BOARD OF COMMISSIONERS

Monday, November 23, 2020 - 6:30 PM

3. Proclamation to Help Hope Live
4. Committee Reports
   A. Resolution # 2020-136 - 208 North Aberdeen Avenue Land Development: (6) Six Townhouses – FINAL – Preliminary/Final Approval

PRELIMINARY/FINAL LAND DEVELOPMENT PLAN
208 NORTH ABERDEEN AVENUE TOWNHOUSES
WAYNE, PA

PRE-DEV DRAINAGE MAP

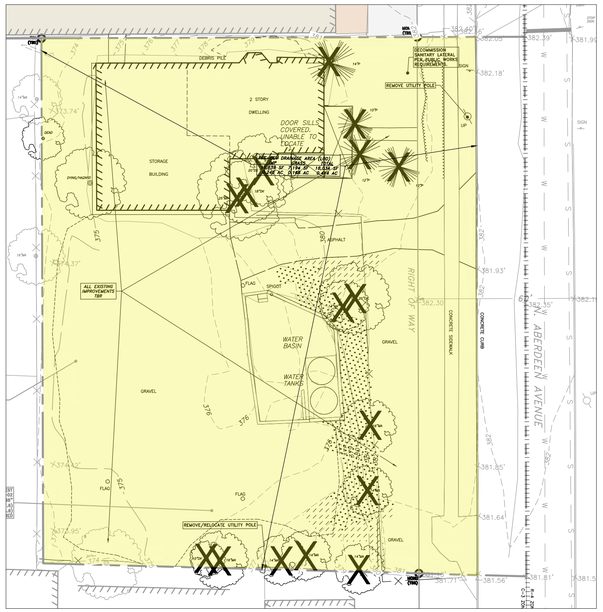
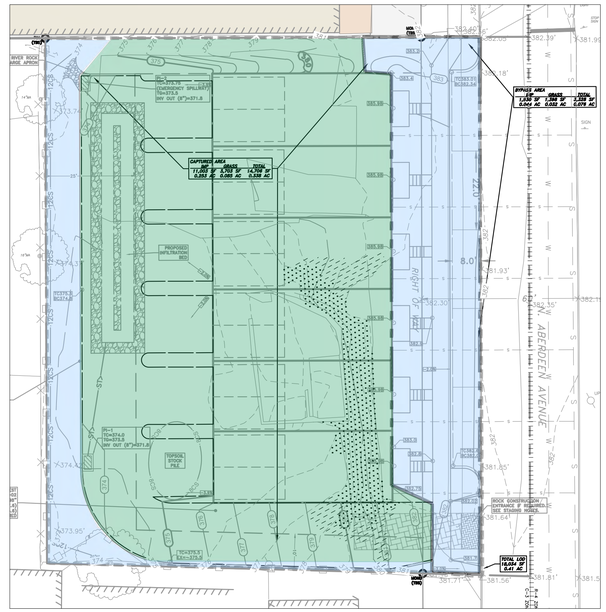
1. It appears that the Post-Dev drainage areas shown on Sheet 4 of the plans do not match the corresponding areas in the hydrograph report. Please revise these inconsistencies. Please provide a scale for the pre-development drainage area map.

Response 3. A pre-dev map and scale are added to Sheet 4.

Response 6. A drainage map is added to Sheet 4.

PROPOSED DRIVEWAY

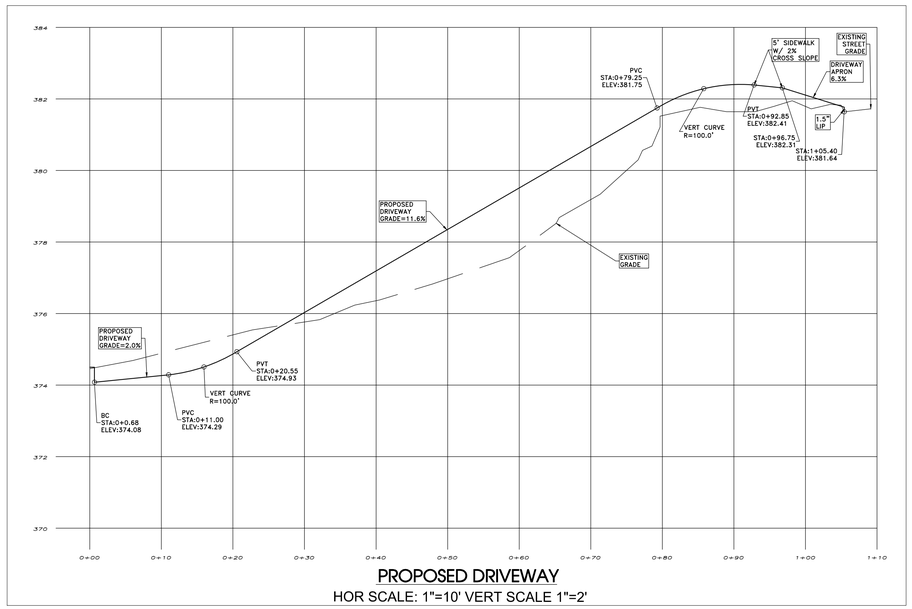
Comment 1. §255-21.B(5)a[1].– Provide the corresponding driveway profile stationing in plan view (Sheet 3 of 6).
Response 1. The alignment is added to Sheet 3.

Response 3. A profile is provided on Sheet 4.
